ANN ARBOR PLANNING DEPARTMENT STAFF REPORT

**SUBJECT: 220 West Ann Street Addition Site Plan for City Council Approval
File No. SP15-035**

Design Review Board

- F-1 15-1037** 220 West Ann Street Design Review - A proposed design for raising the rear roof and adding a covered porch on a vernacular upright-and-wing multiple-family residential building at the corner of West Ann and North First streets. The existing building is clad in vinyl siding which will be used for the proposed addition as well. An exterior stair will also be added as part of the renovations. The site is 4,356 square feet and is zoned D1 (Downtown Core) - Kerrytown Character Overlay Zoning District. (Ward 1)
(Project Number DR15-003, Legistar #15-1037)

Job Title:	220 W Ann St. Renovation	220 W Ann St. Ann Arbor, MI 48104
Sheet Title:	Proposed Elevations	Released For: Site Plan Review

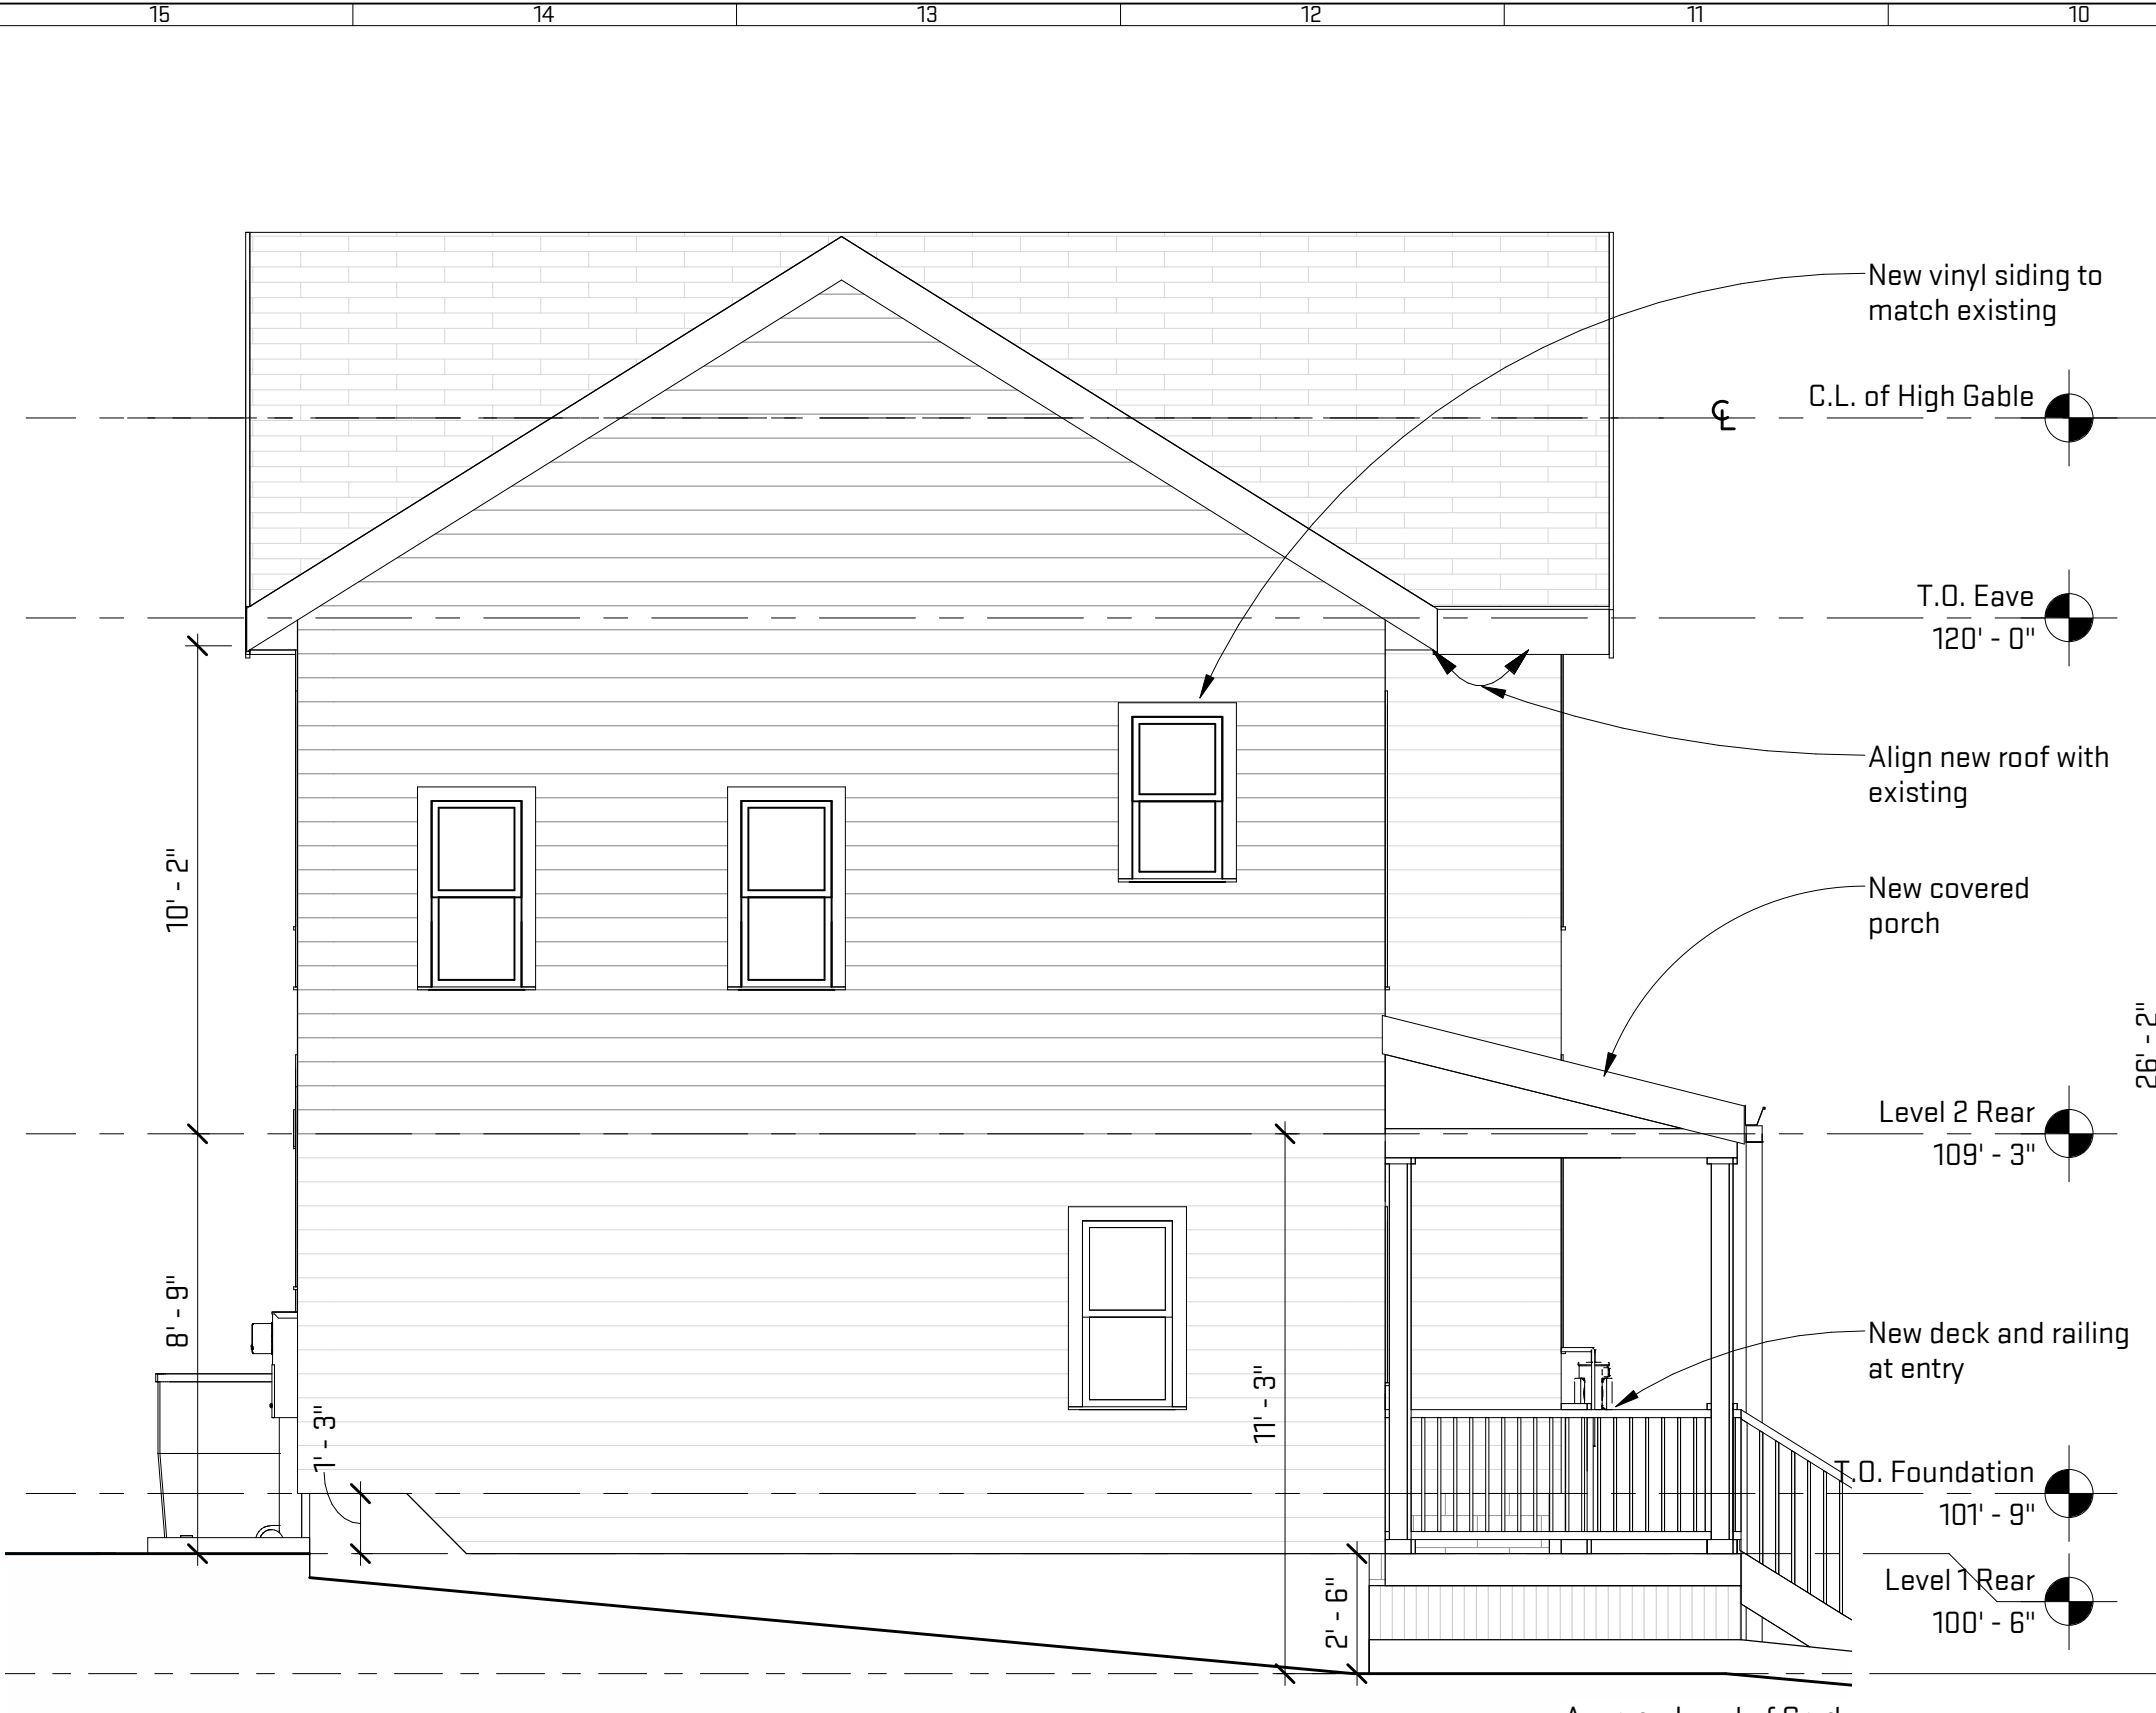
The Development Review Committee Meeting met on August 19, 2015 and recommended changes to the doors and windows to the northern rental unit and screening of the existing gas meters. The petitioner addressed these comments by adding windows and 2 new doors facing N. First Ave. and added landscaping.

The new windows on the raised second story and the rearrangement of windows and doors on the east façade do not appear to have any relationship with the remaining original window openings (C.3.2). The Board suggested, if possible, moving the small bathroom window on the new raised second story from the south west side to the north side of the building. Also, add a window on the north side of the new raised second story for symmetry and additional light into the stairs and hallway of that apartment unit.

The Board noted that some of the sheets in the application showed the bank of meters at the northwest corner of the building covering a window opening, and recommended checking the application drawings for consistency and potential oversights. This same bank of meters appears to extend over a new well at the northwest corner and could impede the use of the well and/or hinder meter reading.
